NEW
RIVER

Burgess Hill

Design & Access Addendum

Proposed Section 73 Amendments

4.2 Leisure Block - Massing Adjustment

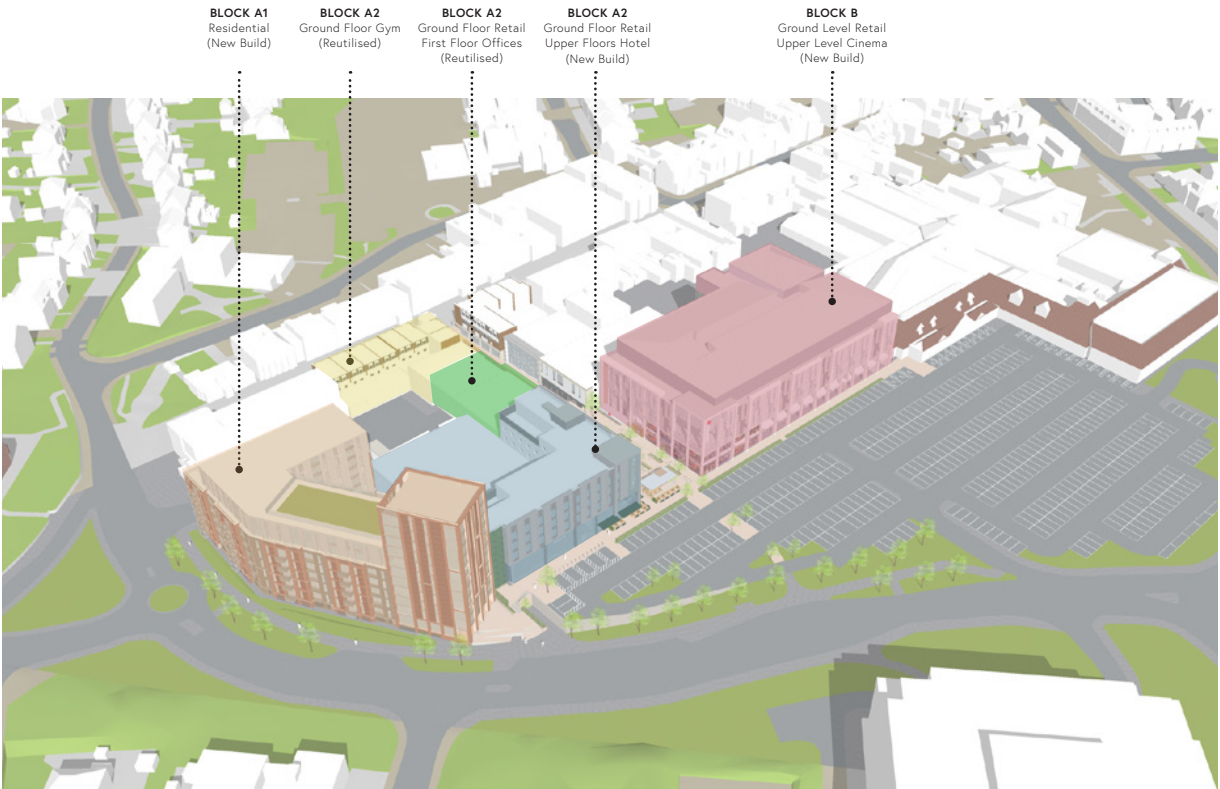
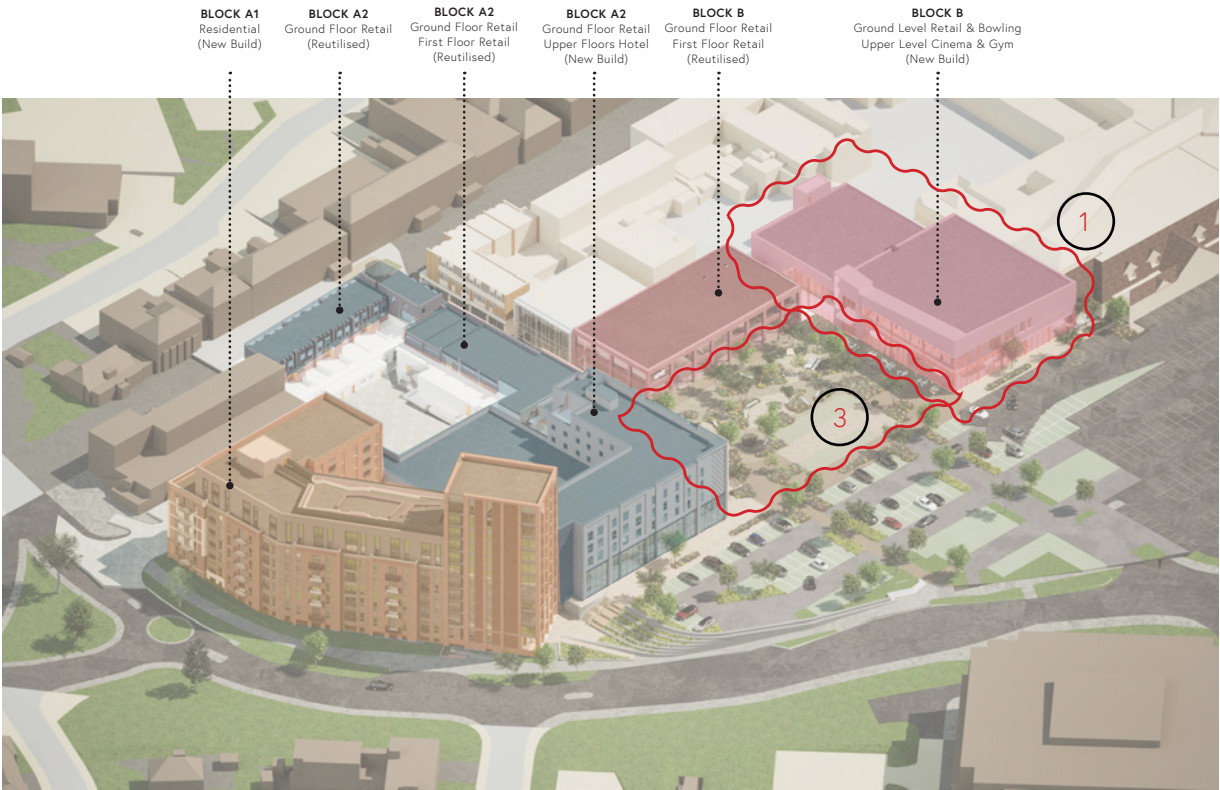
- 1. Previously consented Block B included a 10-screen multiplex cinema. This scale of cinema offering is too large in the current market. The proposed building massing has been reduced to provide a more market appropriate offering including a Boutique Cinema and retail units.
- 2. The North Western half of the building footprint has been removed, reducing the proposed footprint to approximately half of the consented scheme. The footprint of previously consented retail units 18/19 and part of 20 are omitted from the revised proposal.
- 3. The reduced building footprint has facilitated improvements to the public realm as detailed under the following section.

4.3 Leisure Block - Centralised Leisure Facility

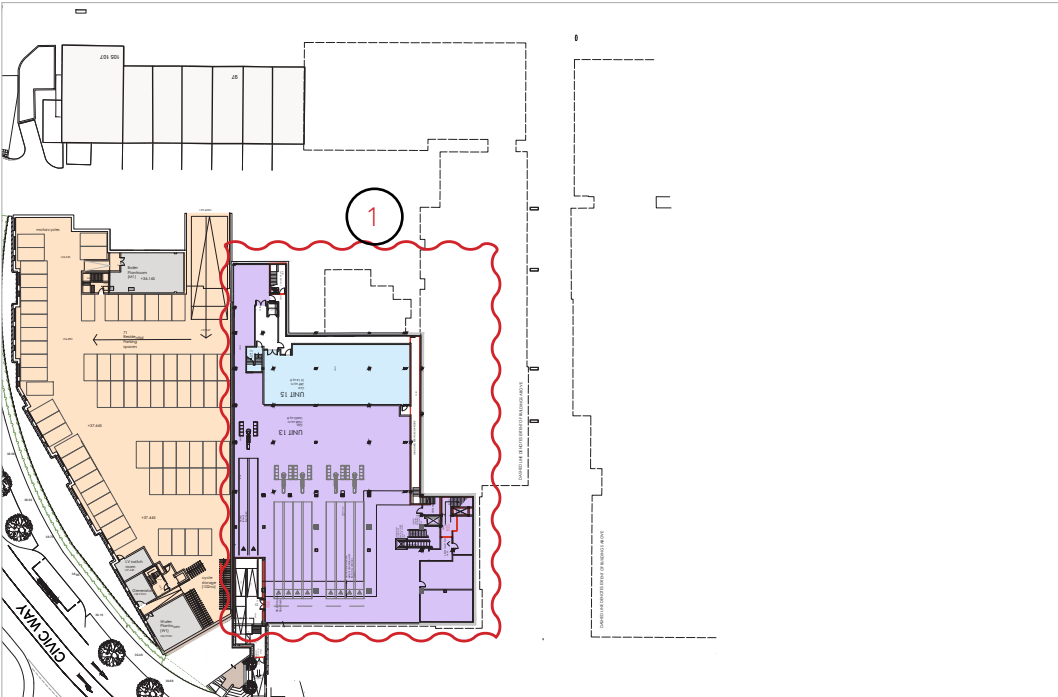
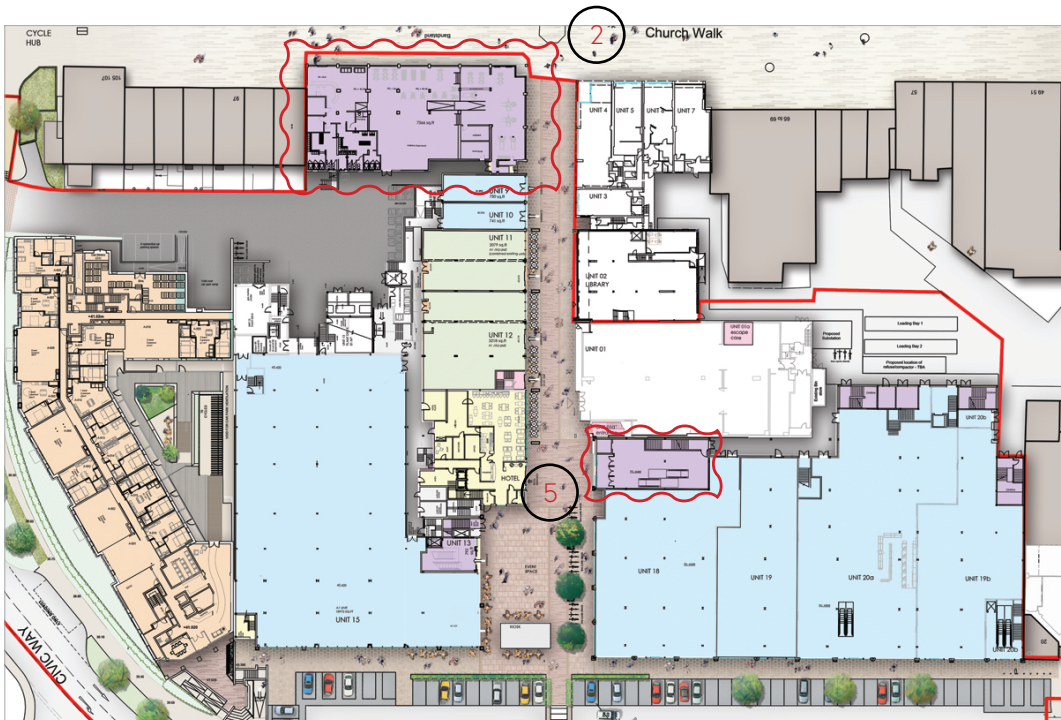
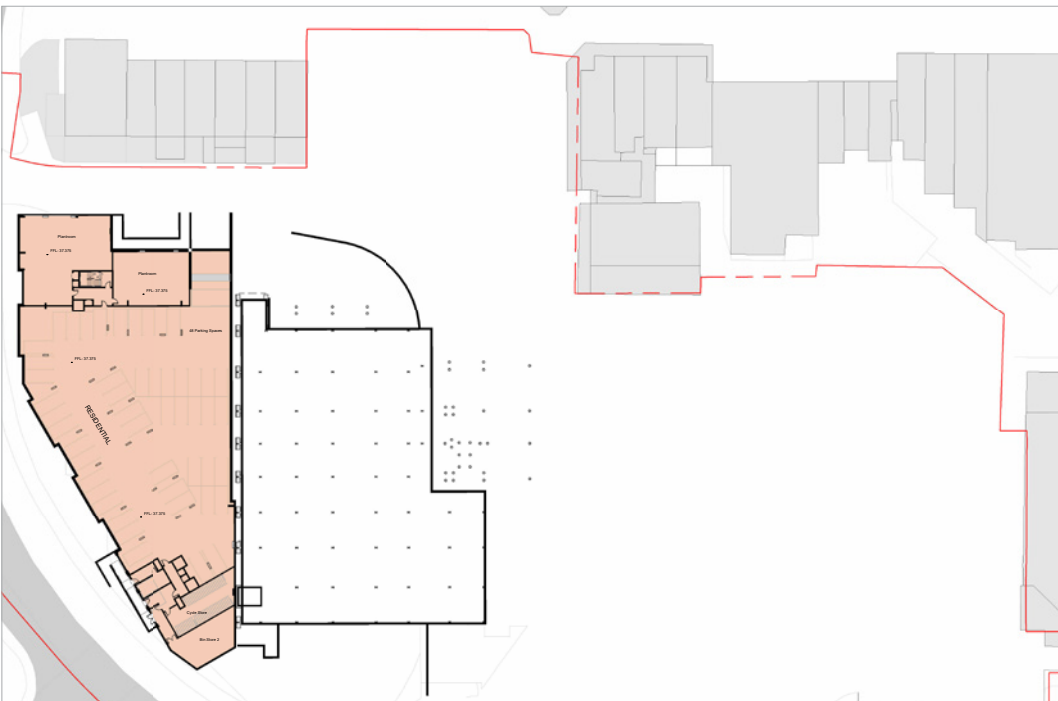
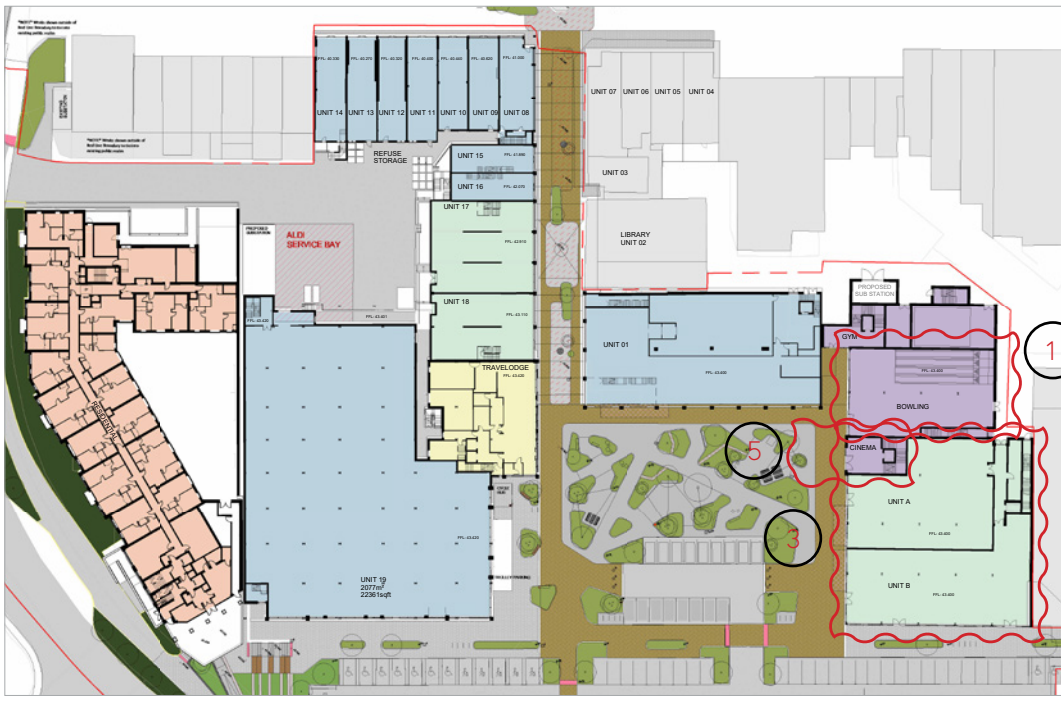
- 1. The previous Bowling Alley (Unit 13) has been omitted from the basement of Block A2 and relocated within the Leisure Building - Block B. The bowling alley will be positioned at ground floor level of the Leisure Building, accessed from the public realm of the new common space.

- 3. Retail provision retained but reduced in overall footprint in line with revised massing. The 3 retail units previously consented are replaced with 2 Retail units provided at ground floor level (Unit A&B) both with frontage onto the new public realm. Both units are intended for Food & Beverage uses.

- 4. Cinema provision retained within Block B. The previous scheme provided a 10 screen multiplex cinema. This has been reduced to a boutique cinema with 4 screens.

- 5. The cinema remains located over the retail provision at ground floor level. Due to the revised massing the cinema entrance is now positioned on the North Western Elevation with access from the public realm of the new common.

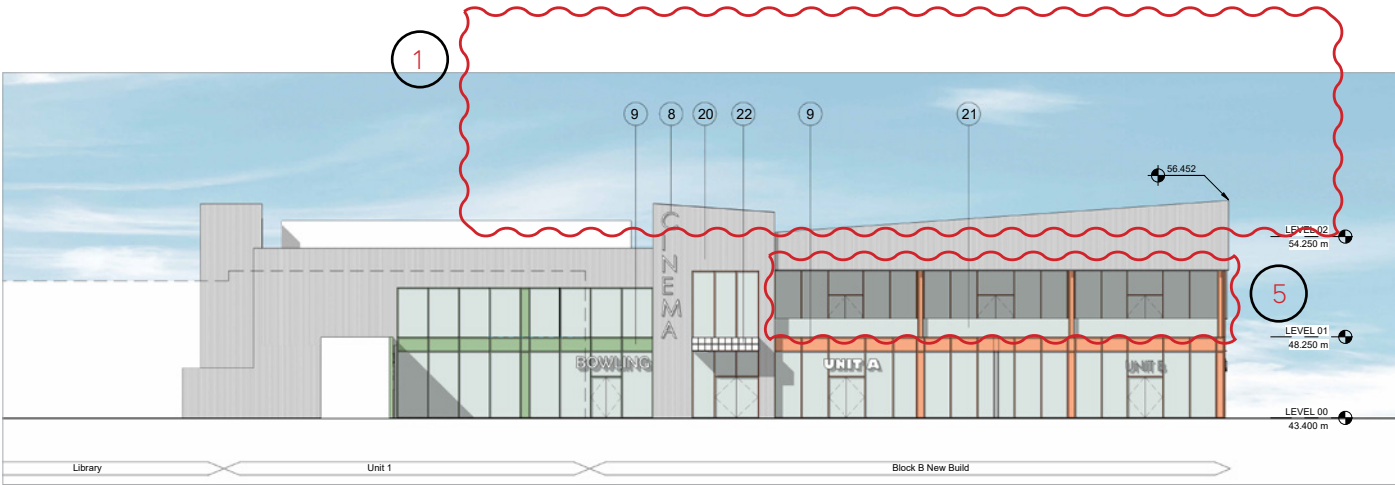
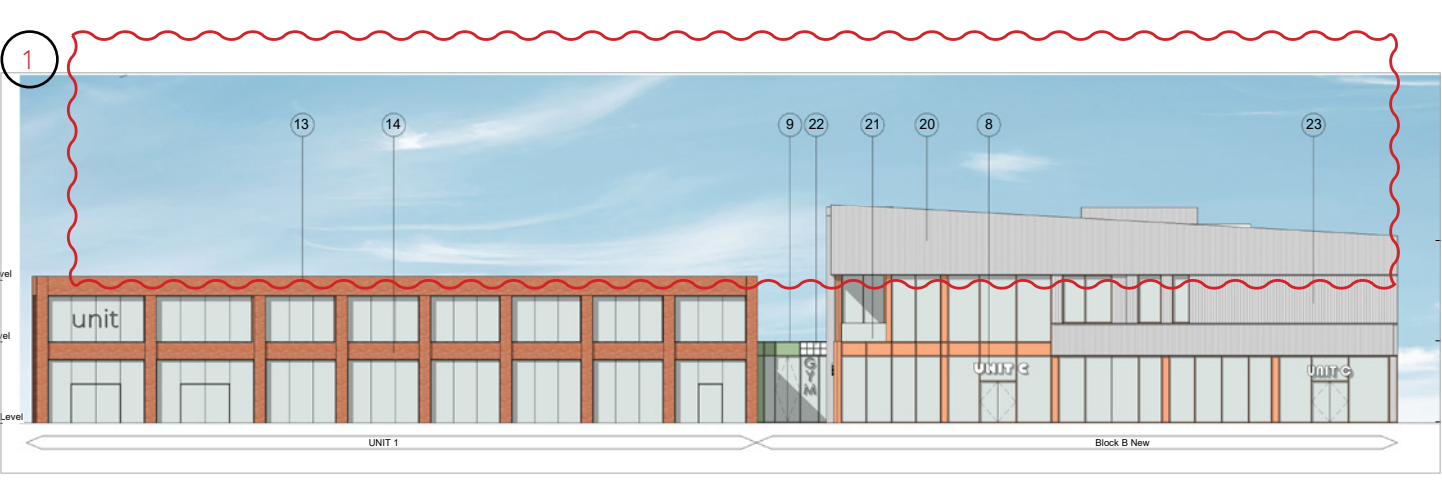
The new proposed cinema has smaller screen sizes reducing the need for large expanses of raked seating and associated ceiling clearance. The height of the building is reduced from 5-storeys to 2-storeys, accounting for a reduction in height from 23.5m to 13.0m from ground floor level. The new height sits more appropriately within the revised proposal and the adjacent existing shopping centre.
2.

The design of the building has changed, the revised proposal focused on the relationship of the proposal to its context, both existing and proposed as well as the viability of delivering leisure provision in the current market.
3.

The consented elevational treatment followed the principle of splitting the horizontal mass into a vertical elements with a series of bays similar to the language of Block A. The significant reduction in the proposed massing has allowed the elevational treatment to be reviewed; structure, glazing and entrance points are used to provide vertical division to the mass rather than bays. This has enabled the block to take on a language that contrasts and compliments the retail rather than copying it - which in turns allows the block to express its leisure use.
4.

The previous materiality uses stone effect cladding panels with a variety of patterns/textures as well as a grey stone effect cladding for the step back upper levels. The revised materiality balances silver corrugated metal panels with coloured aluminium glazing.
5.

Inclusion of a terrace within the cinema provision provides depth to the façade.

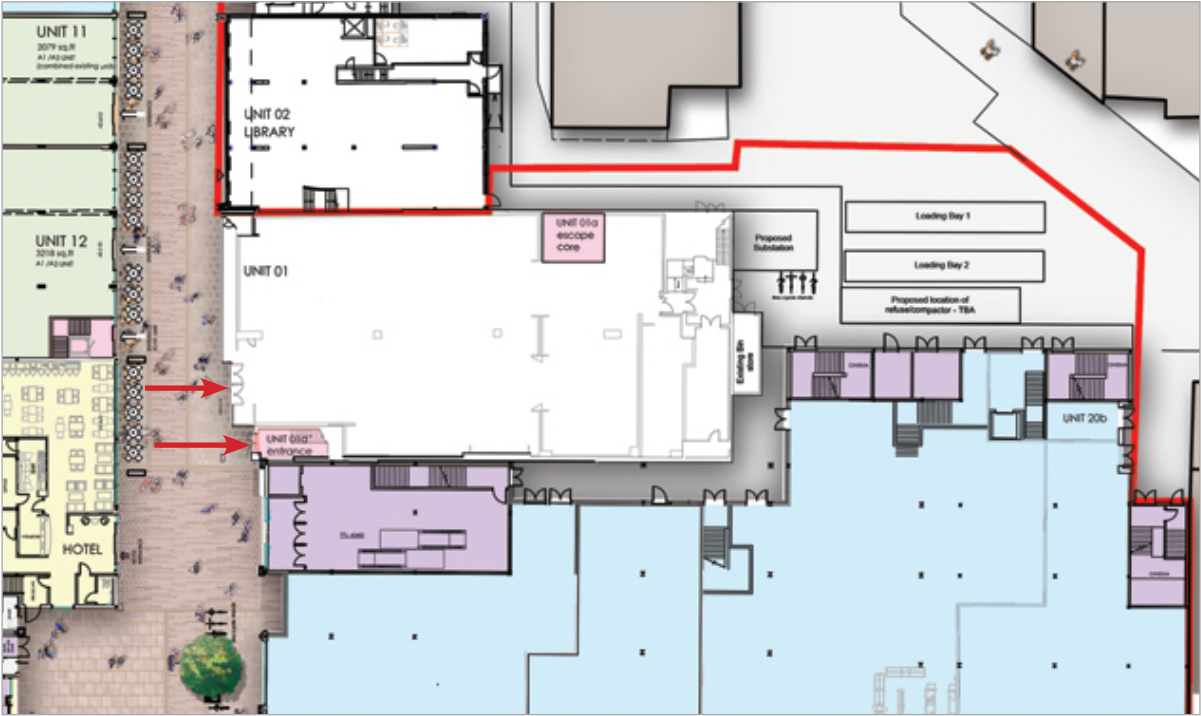
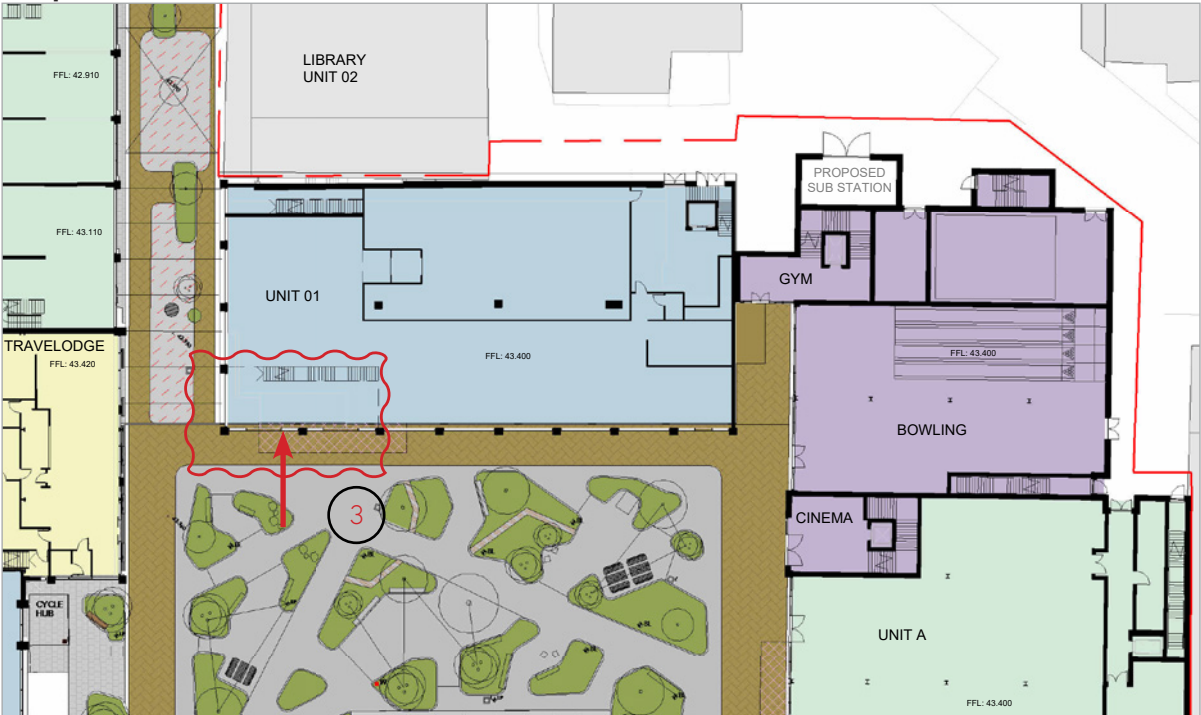
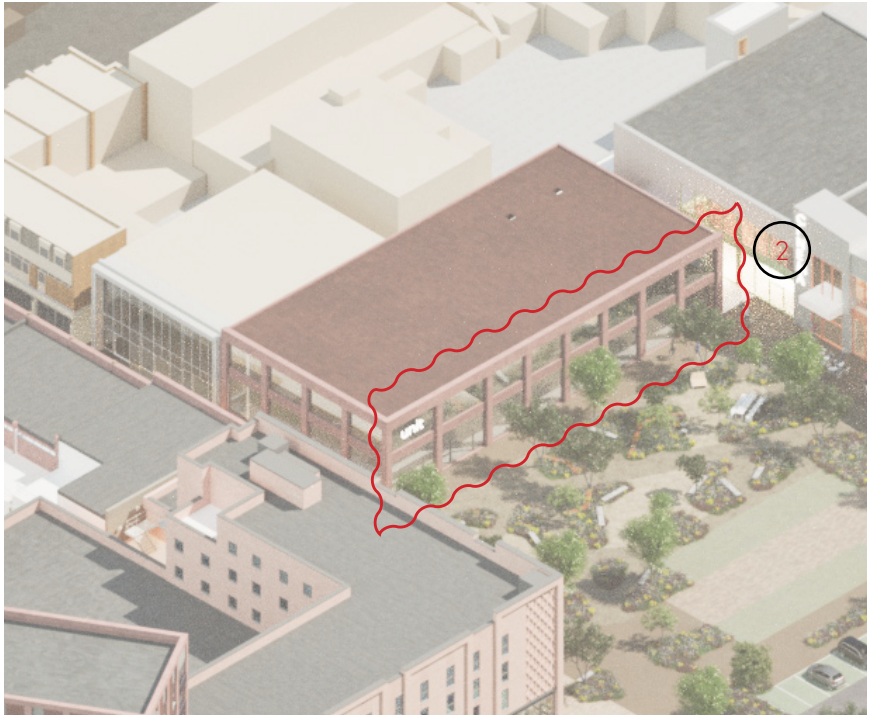
- 1. The consented scheme allowed for 2 separate retail units - Unit 01 at Ground Floor and Unit 01A which was a separate unit at first floor which direct access from ground level. The revised proposal combines both units to provide a larger retail unit over 2 levels.

- 2. In the consented proposal the new multiplex cinema/retail building directly abutted the boundary wall of Unit 01. The cinema entrance was adjacent to the Unit 01a entrance. As a result Unit 01 had frontage to on its North Western Elevation only. With the reduction to the leisure block massing and the revised positioning, as outlined above, the South Western boundary of Unit 01 will no longer abut to a building. Unit 01 will now have store frontage along the length of its South Western facing elevation, fronting onto the new public realm.

- 3. Both Units 01 and 01a were previously accessed from Church Walk opposite the Hotel & Unit 12. With the above changes, the store entrance is relocated to the south western side to optimise the revised layout and relationship with the common. The separate entrance lobby to the staircase leading to the first floor is demolished and a large atrium opened up over the store entrance in line with tenant preferences.
